IN THE DRAWINGS

REMARKS

FIG. 5

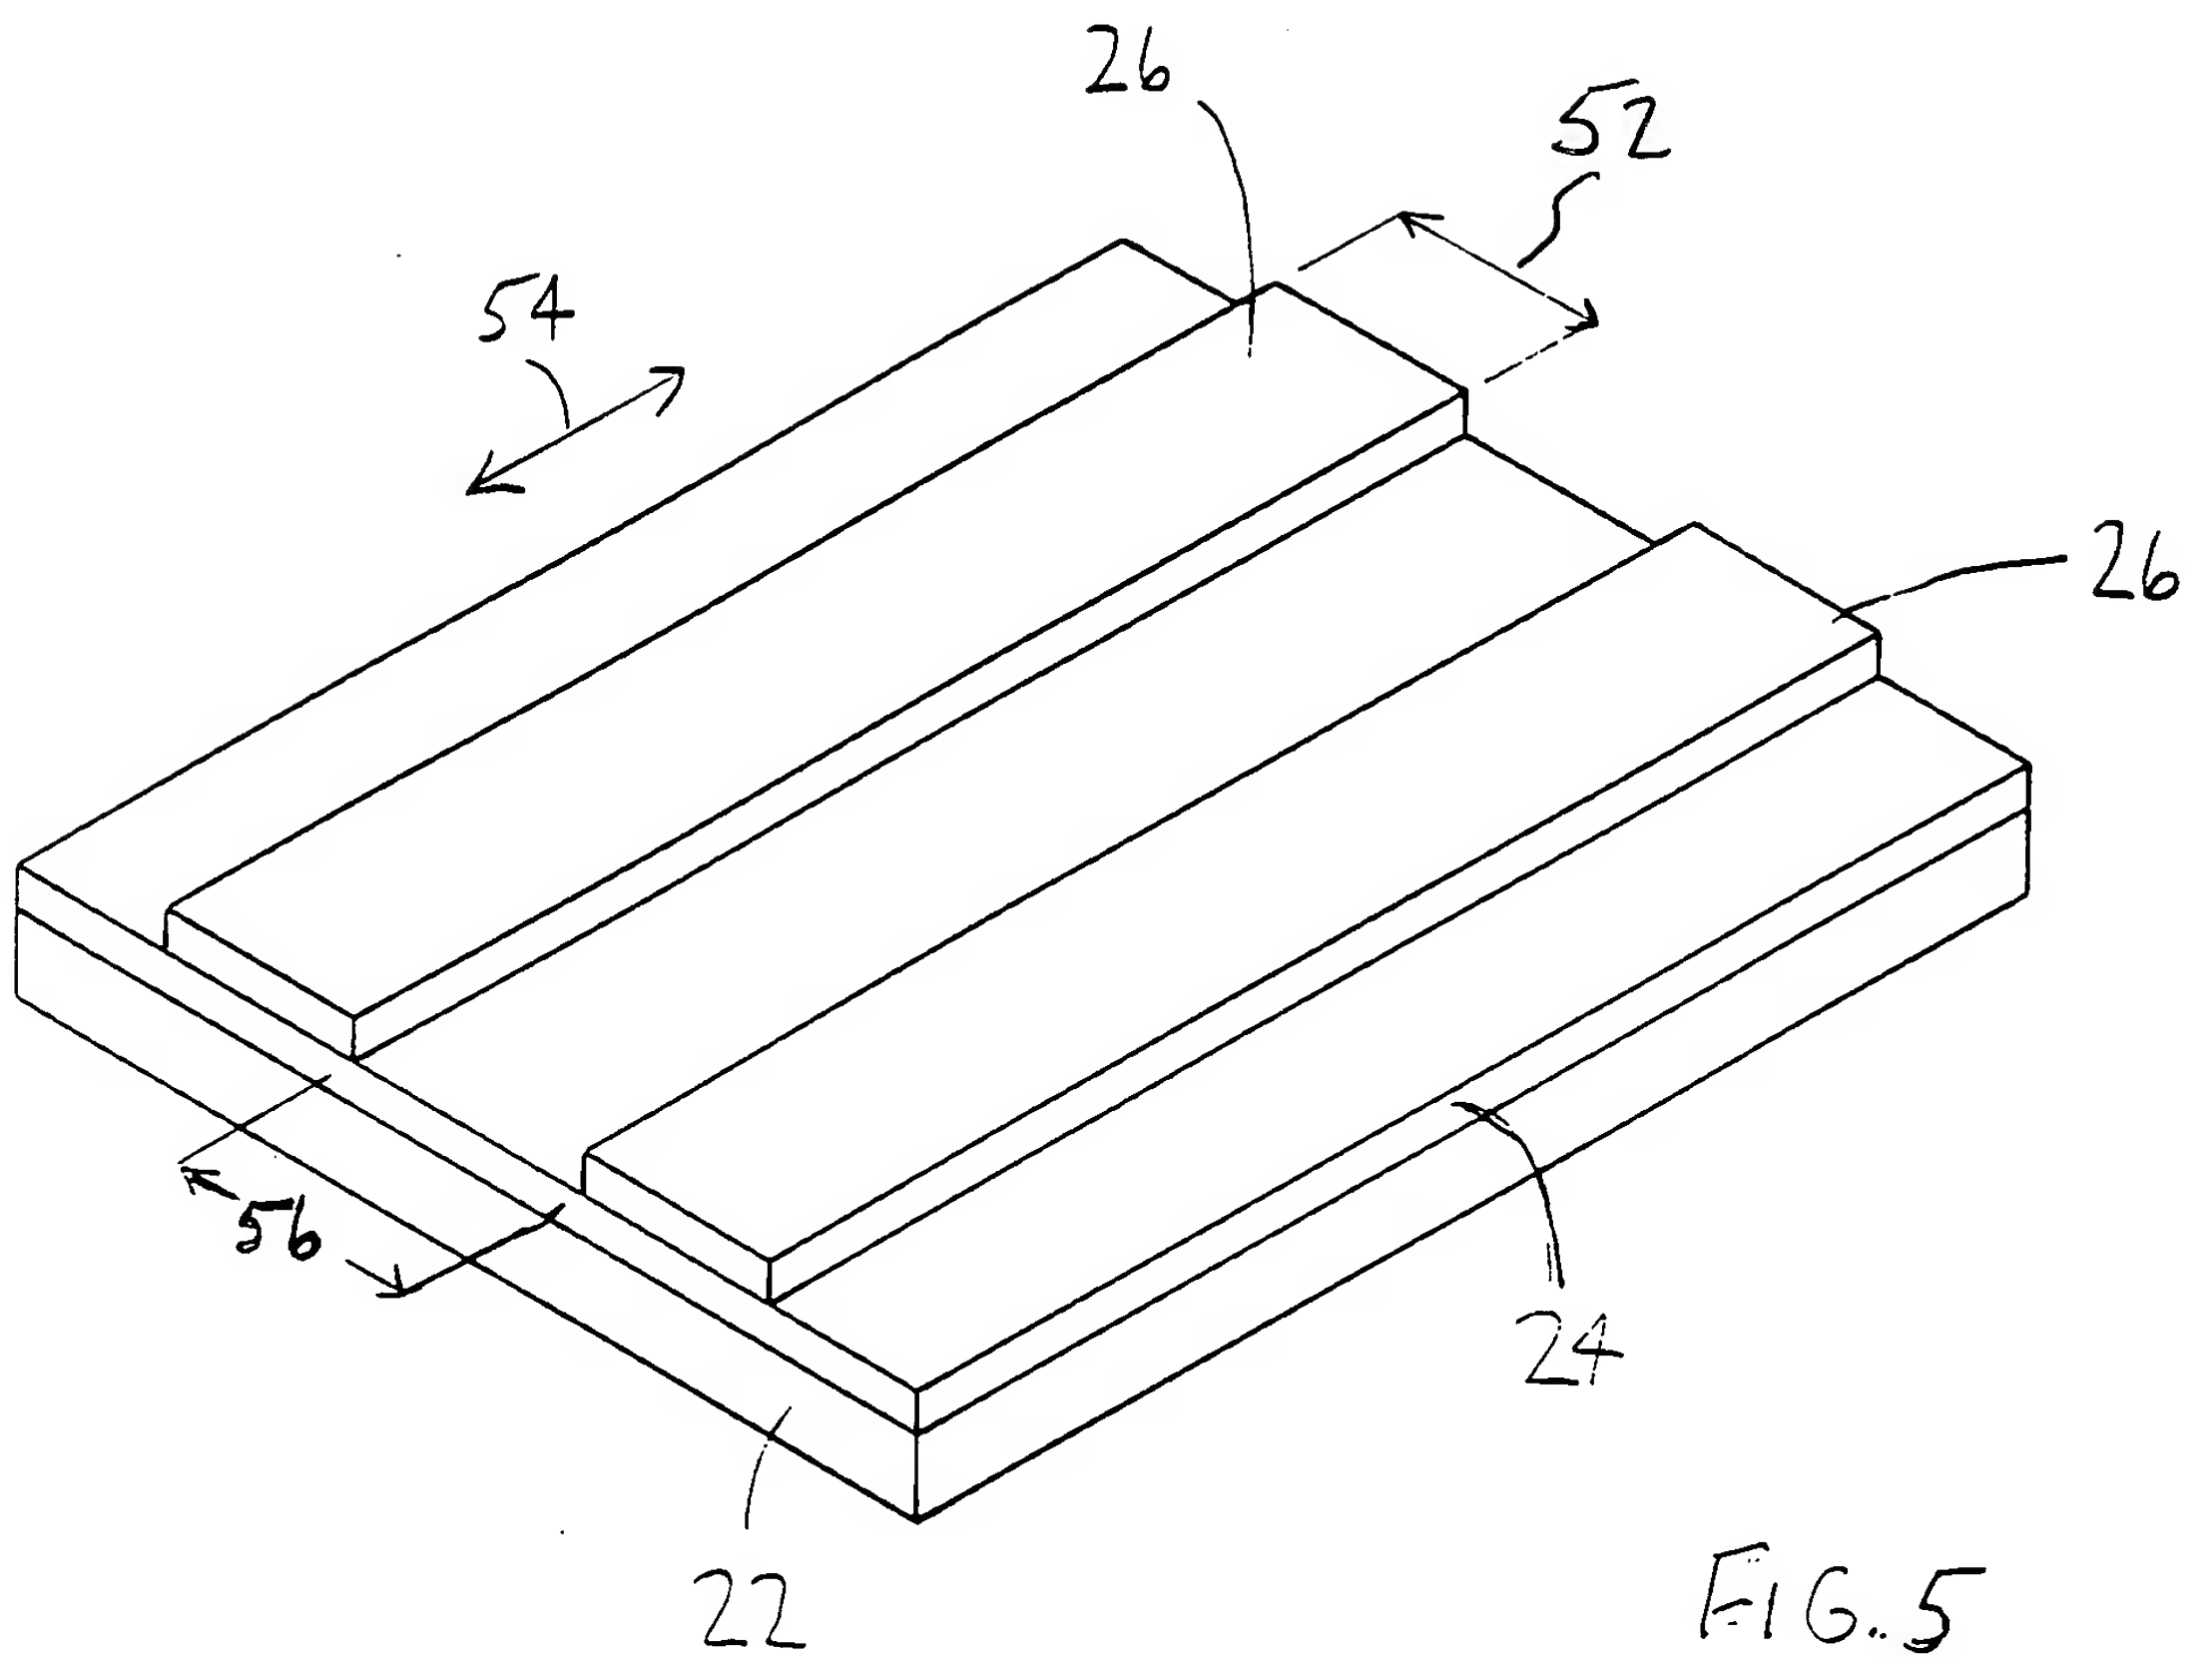
The Examiner objected to the drawings as failing to comply with 37 CFR 1.84(p)(5) because they do not include the following reference sign mentioned in the description: 52 in Fig. 5.

Applicant has submitted a replacement sheet of drawings including a revised Fig. 5.
